**Meeting Date:** Tuesday 8 August 2017  
**Location:** Council Chambers, Level 1A, 1 Pope Street, Ryde  
**Time:** 5.00pm

**NOTICE OF BUSINESS**

- 
- 2 6 LEXCEN PLACE, MARSFIELD. LOT 70 DP 718680. Development Application – Demolition, new residential apartment building comprising 4 x 3 bedroom apartments over a semi-basement parking level for 6 vehicles - under the State Environmental Planning Policy (Affordable Rental Housing) 2009. LDA2017/0167**
-

**Extract of the 9am shadow diagrams for the amended proposal at the winter solstice. Noted in this image the shadow impacting upon the dwelling house at 10 Lexcen Place.**

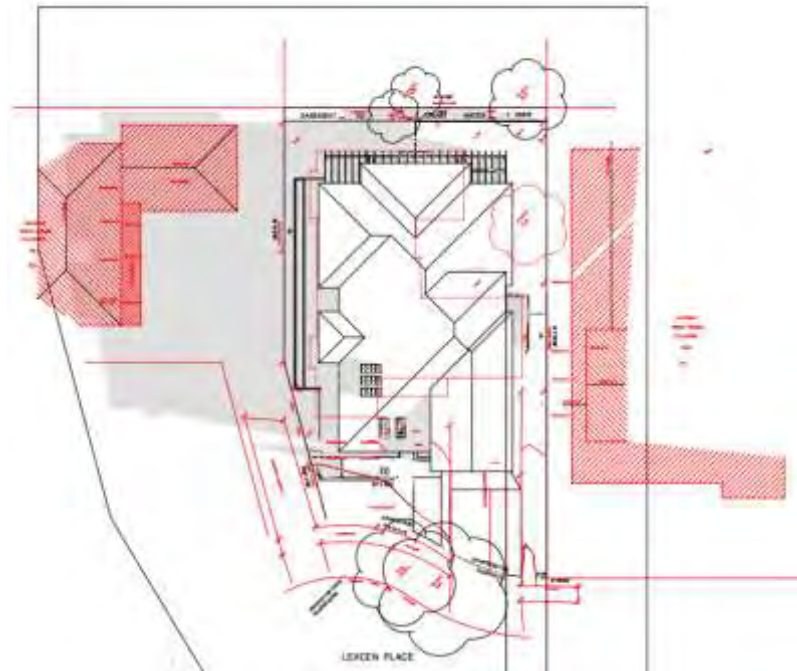
With regard to future solar panels to be located at 10 Lexcen Place, it is noted the shadow diagrams reveal solar access will be achieved to the roof of this adjoining dwelling from approximately 10am onwards at the winter solstice. As such, a satisfactory level of solar access will be afforded.

It is noted that the proposal includes a compliant overall building height, and is also setback from the boundary by 3m. A compliant dwelling house could be erected on the subject site that is 9.5m high and located only 1.5m off the side boundary. Given the above, the objections raised in relation to solar access/ overshadowing are not supported in this instance.

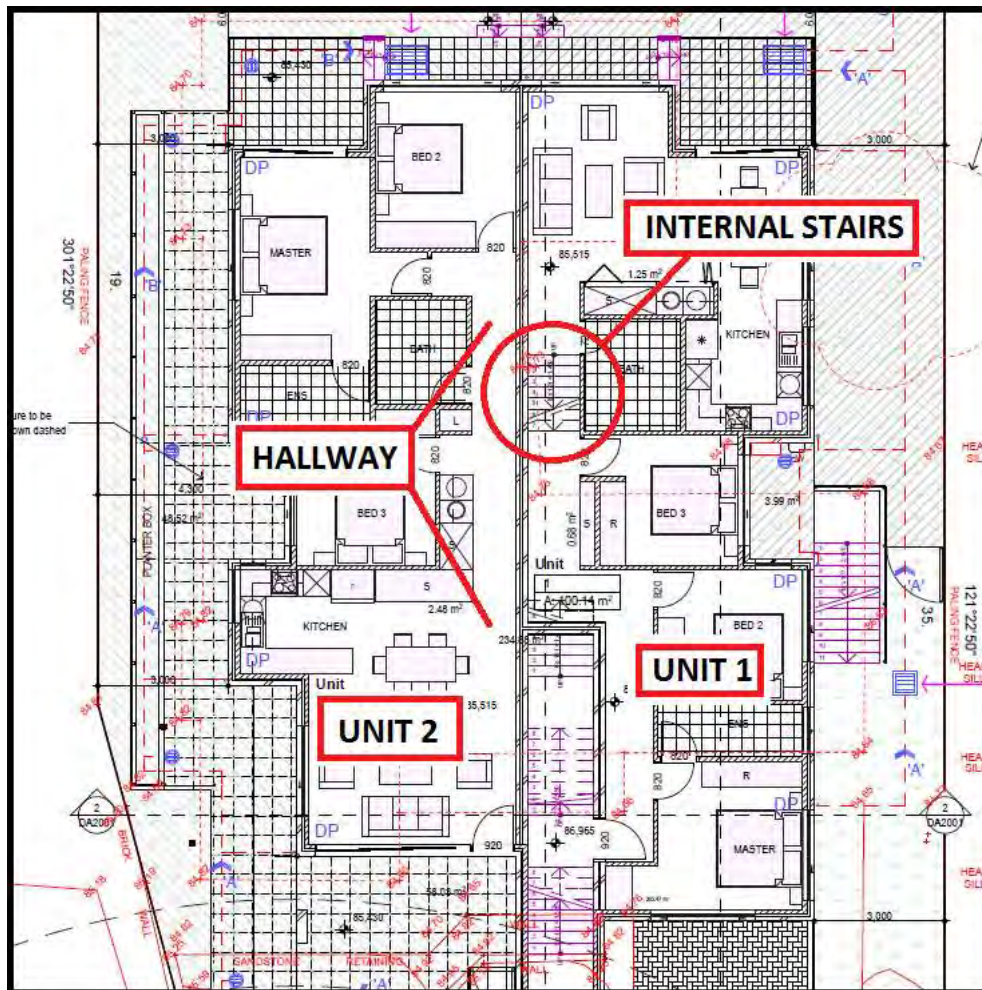
While it is acknowledged the applicant's amended plans have now ensured all apartments meet the minimum areas prescribed by the ADG, it is argued the poor layout of the apartments offends the objective of this guidelines outlined above.

In particular, the UDRP comments on the excessive amount of hallway areas is noted, along with the inclusion of staircases within the Unit 1 and Unit 3 of the development.

Figure 11. North east elevation – College Street – identifying street level uses

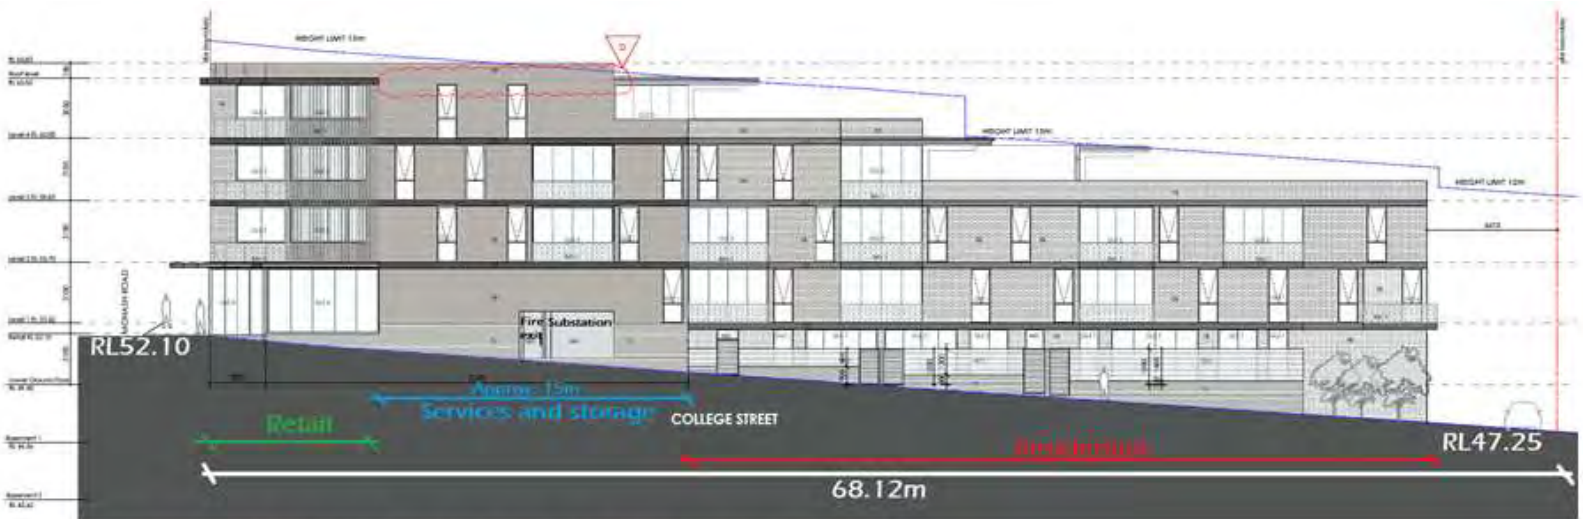
**Figure 11** identifies the street level uses which are over the lower ground and ground levels of the development. The site has a slope of 4.75m from the corner of Monash Road and College Street to the rear of the site. **Figure 12** provides a photograph of this elevation of the existing site.

**Figure 14. Basement 1 and Lower Ground Floor Plan identifying access way and deep soil areas**

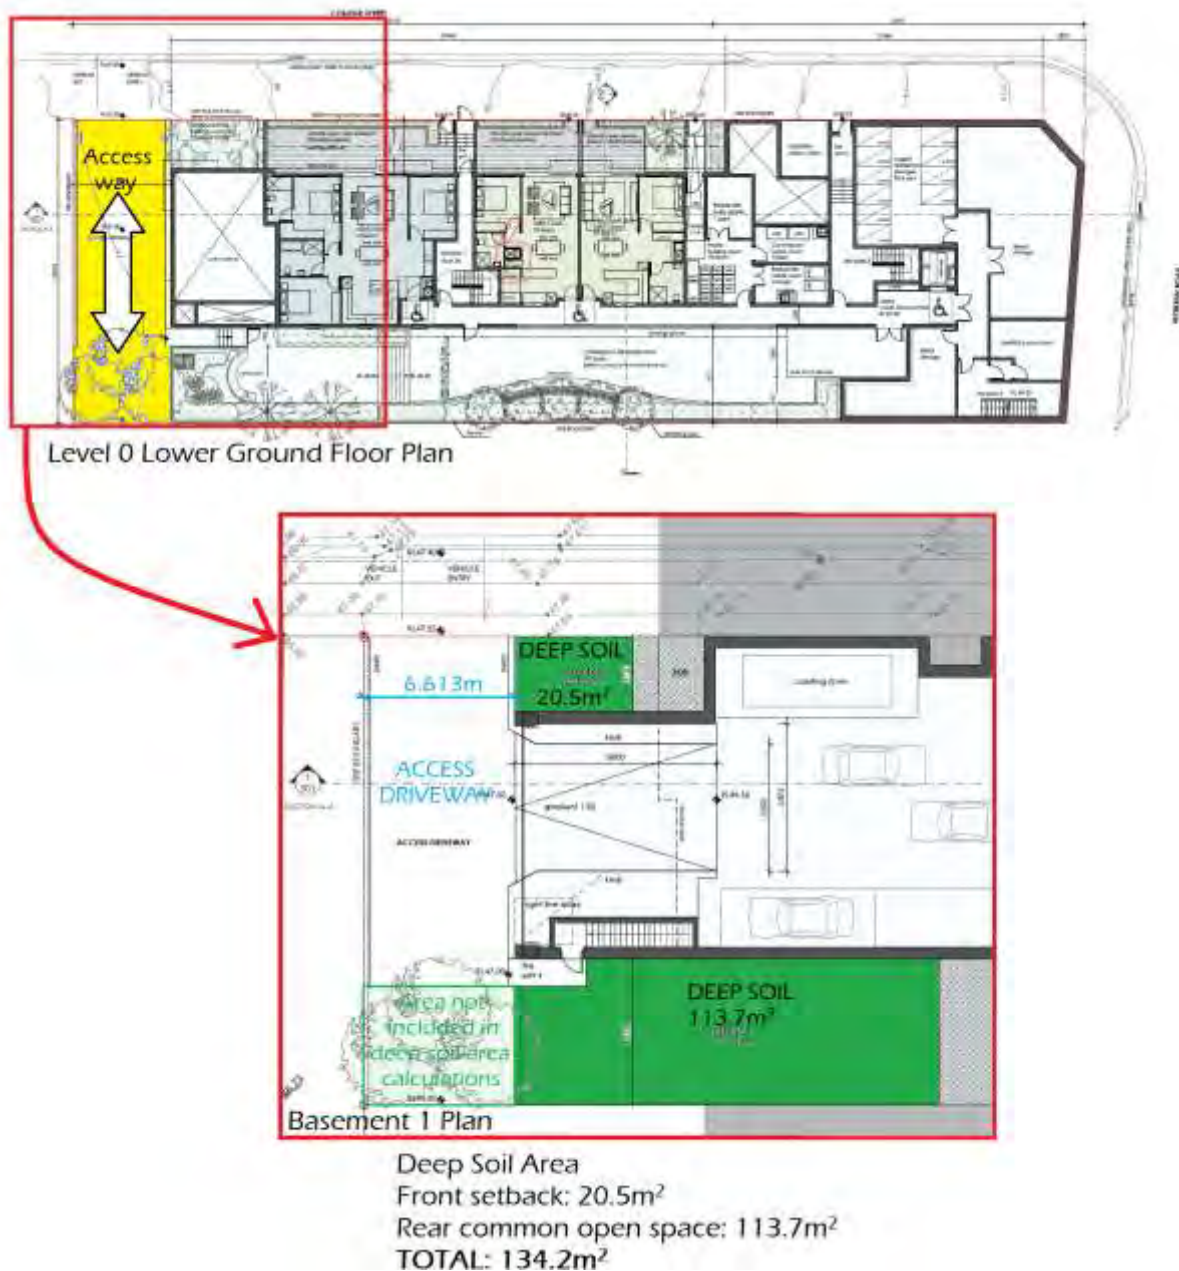
A small strip of landscaping is proposed adjoining the site boundary and the access driveway, identified in **Figure 14** as '*Area not included in deep soil area calculations*'. Should an easement be registered in accordance with the access requirements of Ryde DCP 2014 Part 4.6 – Gladesville Town Centre and Victoria Road Corridor, **Condition 162** has been recommended on the draft consent allowing for the removal of the temporary landscaping, or allowing for the temporary landscaping not to be planted if it has not yet been planted.

Approximately 134.2m<sup>2</sup> (or 9.9% of the site area) is proposed as deep soil zone in the form of the common open space area along the site's southern boundary and within the front setback area, as shown at **Figure 14**, without relying upon deep soil landscaping at the south western end of the driveway in the area of the potential future right of way. This amount of deep soil planting exceeds the ADG requirement for 7% deep soil planting and accordingly is not a reason for Council to refuse the application.

**Figure 18. Building Section Plan of proposed development identifying height exceedances Clause 4.6 Exceptions to development standards – Height of building**

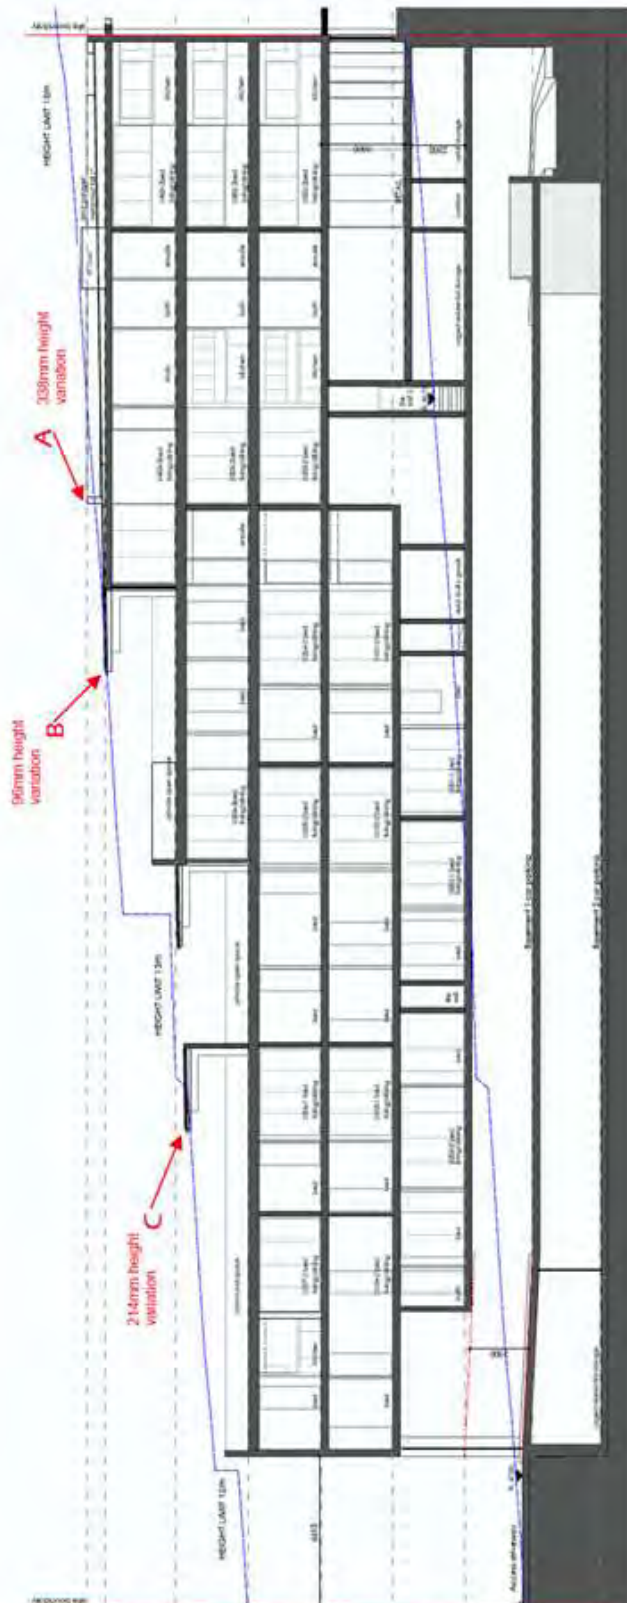
**Table 1 and Figure 18** depict the maximum building height of the proposed development within the 12m, 13m and 15m height control areas shown at **Figure 17**, and identify that maximum height of the proposed building slightly exceeds the respective 13m and 15m height zones applying to the site in three areas identified as area A, B and C.

The proposal departs from this development standard by a maximum of 338mm within the maximum height control of 15m (Area A), and 214mm within the maximum height control of 13m (Area C). The height exceedances are shown at **Figure 18** and outlined above at **Table 1**. The height variations are:

**Right wintergarden window taken at 9.45am 21 June demonstrating the lack of sunlight penetration into the space.  
Source: CPS, 21 June 2017**

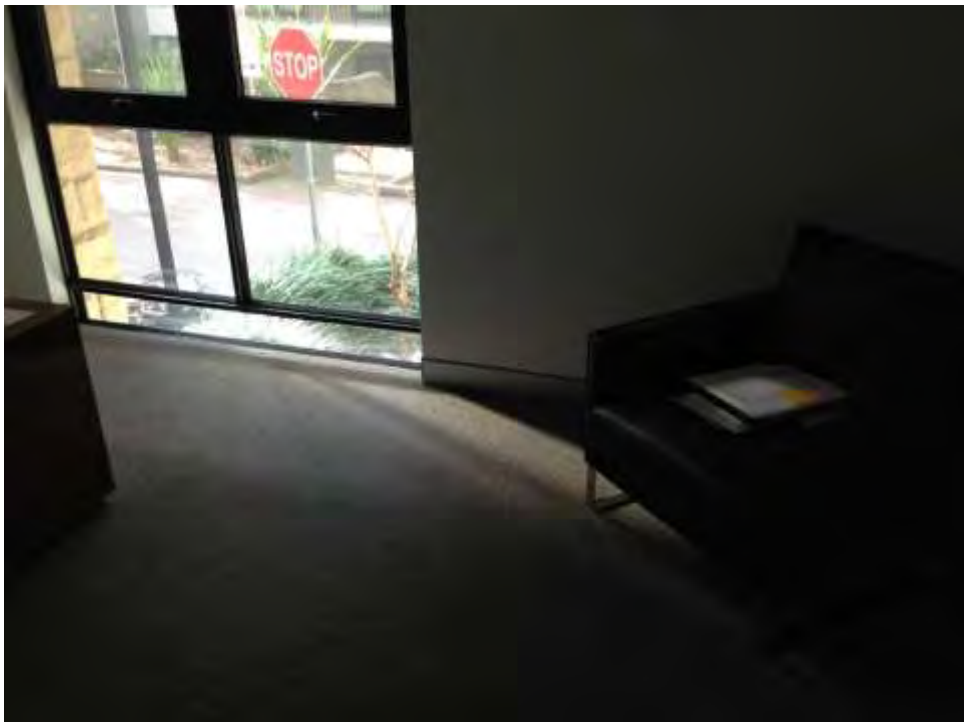
Additionally, during the site inspection, at 9.45am it could be seen only a narrow slither of direct sunlight, well under the guidance for a minimum of 1m<sup>2</sup>, penetrates into the winter garden space and as such the sunlight that is received would have limited amenity benefits for residents – see photos below. The slither of sunlight and the general lack of daylight in this winter garden space can be seen in the photographs taken on site at 9.45am which is close to the best time for solar access to this space. The darkness in this space would increase throughout the day as the sun moves to the west behind the building.

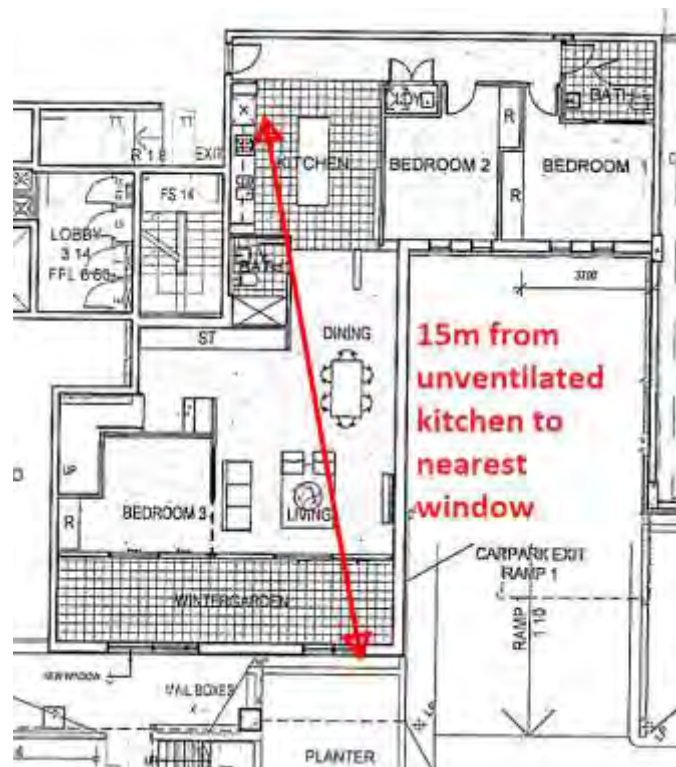
The proposed apartment includes windows to all habitable rooms. The plans provided do not indicate whether these windows are openable, however the applicant has indicated that these windows can be made openable should that be required. Despite this, the windows to Bedroom 1 and 2 are located directly above the carpark entry door and it is considered that even if they were openable, it is likely that they would often be kept closed due to the significant noise and vehicle emissions from the car park entry and roller door. Accordingly, it is considered that natural ventilation to these rooms will be compromised by these factors and as such the objectives of natural ventilation have not been achieved.

**Marked first floor plan the windows/glass sliding doors to living and bedroom 3 are on an internal wall and not an external wall as required.**

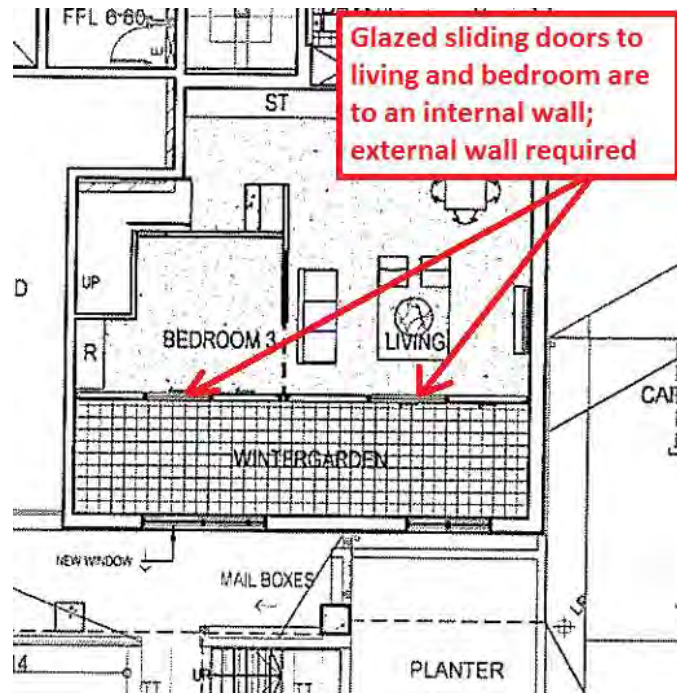
The proposal includes a number of rooms of concern in relation to the provision of windows to external walls and associated daylight access. Bedroom 3 and the open plan living area both have a glass sliding door frontage to the proposed wintergarden space (see drawing below). As is discussed in further detail under point 5 below, the proposed wintergarden is considered to be a highly internalised space with relatively poor access to natural ventilation and solar access that are fundamental to an area of 'open space'. The result of this is that the frontage of Bedroom 3 and the living area to this space is not considered to satisfy the requirement for a window to an external wall. The implications of this area are lack of sunlight and daylight penetration to the space and poor natural ventilation.

**Marked ground floor plan indicating the removal of the front door and new indirect access to the commercial premise via the residential lobby.**

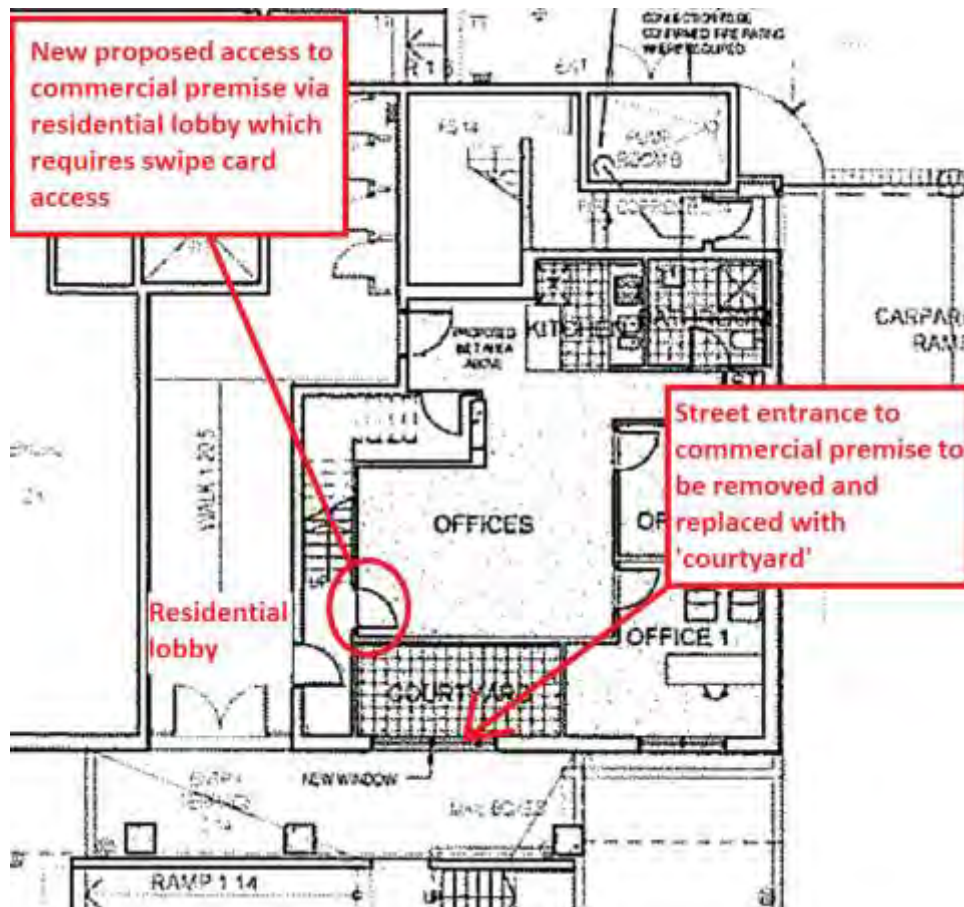
The proposed apartment includes bedroom windows located immediately above the entrance to the building car park and garage roller door which is likely to significantly impact the acoustic privacy of the bedrooms and the dwelling. No acoustic report has been submitted to verify whether the proposal will achieve the requirements of AS 3671. Refer to Point 7 under the ADG section above for further discussion.
